# Hampden Rd Master Plan and Hampden/Broughton intersection papers

comment by Peter Egan

**Document – Artarmon Local Centre Public Domain Master Plan** – comment follows that on the intersection document

## **Document – Hampden Road/ Broughton Road Intersection - Willoughby Council Intersection Options Assessment and Feasibility Study by GTA**

**Figure 22 Herbert St – Punch St – cycle paths junction improvement**

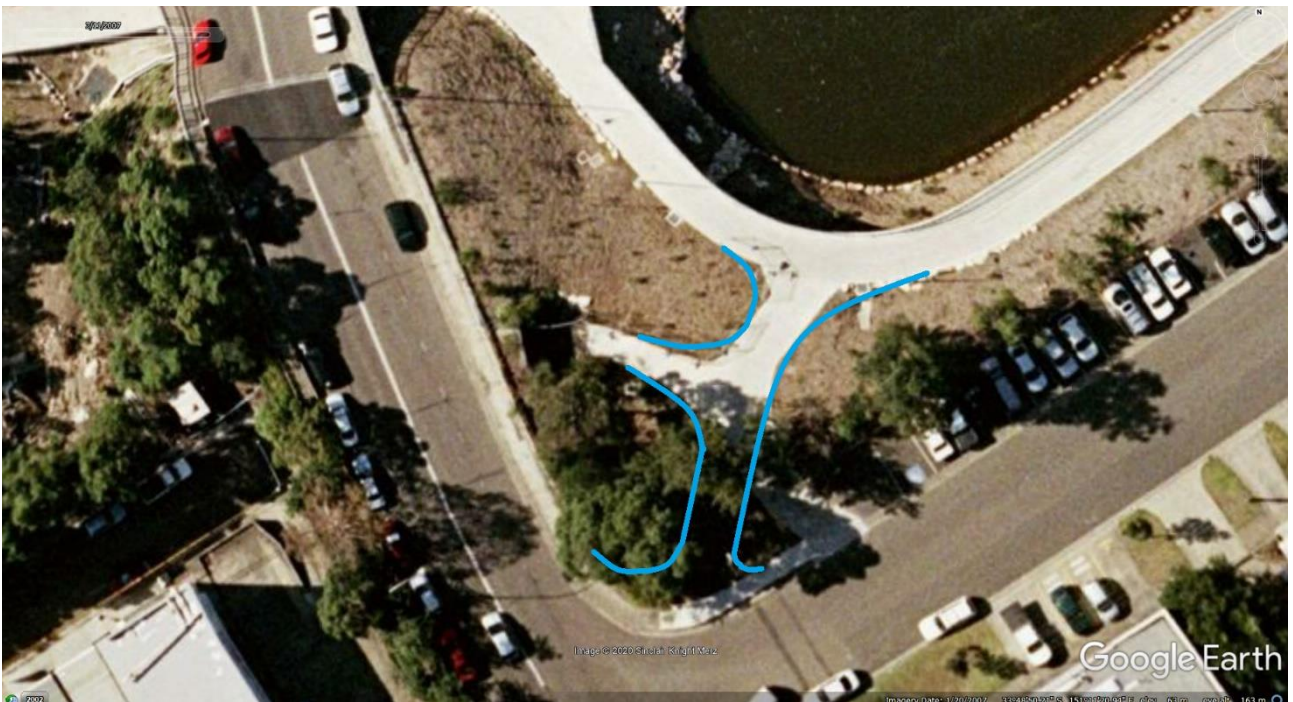
See Figure 22 – the connection to cycle path needs improvement to directly connect to the path beside the motorway. Clear directional signposting required here and throughout route.
